# SERVICE BULLETIN

TR-7800

# 829

SUBJECT: TR-7800 LOSS OF MEMORY

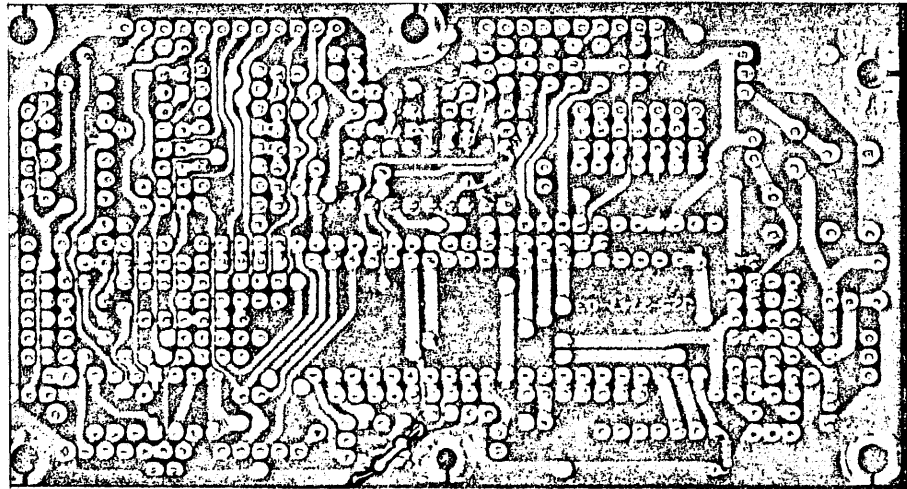
Intermittent loss of memory may be corrected by adding one resistor at the  $\mu$ -processor on the Control unit.

1. Remove bottom cover, 4 screws.
2. From the Control unit X53-1180-xx unplug the rear mounted connectors 8-11.
3. Remove 6 screws from the board.
4. Swing the unit forward.
5. As illustrated, install a  $470K\Omega$  1/8W or larger resistor from connector 11, "UP" pin, to ground. ( $\mu$ -proc pin 35, PA2 port). Space is limited: Be certain not to create a solder bridge when installing the resistor.
6. Reverse steps 4-1 for reassembly.

470 K $\Omega$
